Access Compliance Report

Public Rights-of-Way

Intersection ID: 32271	Main Street: SPRINGWELL_ST	Cross Street: SULLIVAN_RIDGE_DR	Location: SW
ADA ID: CD85A2DEE2F2	Ramp Type: PerpDiag	Initial Pass/Fail: Fail	Overall Compliance: No
Severity Score: 22.5			
Codes/Mitigation Info/Possible Solution		Field Measurements/Component Compliance

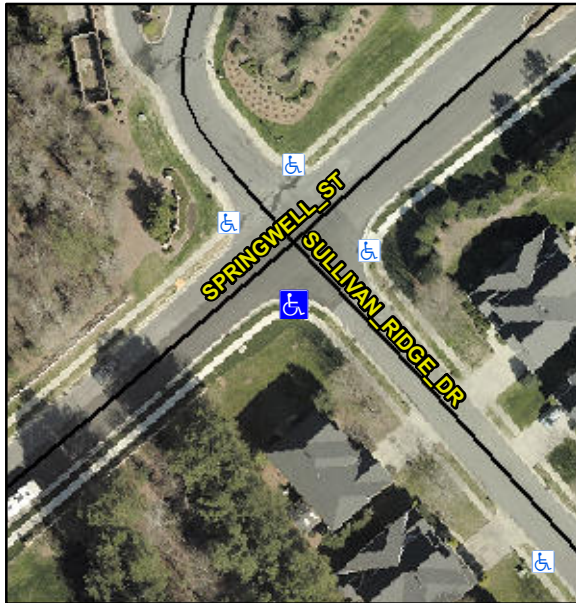
Not Found, R304.5.1, R304.2.2, R304.5.3

Compliance	Description	Data	Compliance	Description	Data
N/A	Ramp Length (in)	68.0	No	Ramp Slope (%)	10.5
No	Ramp Width (in)	43.0	No	Ramp XSlope (%)	3.8
N/A	Flare Type LT	N/A	N/A	Flare Type RT	N/A
N/A	Flare Slope LT (%)	N/A	N/A	Flare Slope RT (%)	N/A
N/A	Flare Traversable LT?	N/A	N/A	Flare Traversable RT?	N/A
N/A	Landing Length (in)	N/A	N/A	DWS Provided?	N/A
N/A	Landing Width (in)	N/A	N/A	DWS Contrast?	N/A
N/A	Landing Slope (%)	N/A	N/A	DWS Length (in)	N/A
N/A	Landing X Slope (%)	N/A	N/A	DWS Full Width?	N/A
N/A	Landing Curb? (Y/N)	N/A	N/A	DWS Offset (in)	N/A
N/A	Shared Landing?	N/A			
N/A	Gutter Ponding?	N/A	N/A	Gutter Slope (%)	N/A
N/A	Gutter Lip Ht (in)	N/A	N/A	Gutter X Slope (%)	N/A
N/A	Painted X Walk1?	No	N/A	Painted X Walk2?	No
	X Walk 1 Direction	To NE		X Walk 2 Direction	To NW
N/A	X Walk 1 Width (in)	N/A	N/A	X Walk 2 Width (in)	N/A
	X Walk 1 Slope (%)	4.6		X Walk 2 Slope (%)	0.2
	X Walk 1 X Slope (%)	0.7		X Walk 2 X Slope (%)	3.9

Remove & Replace Curb Ramp With Two New Directional Ramps or Equivalent.
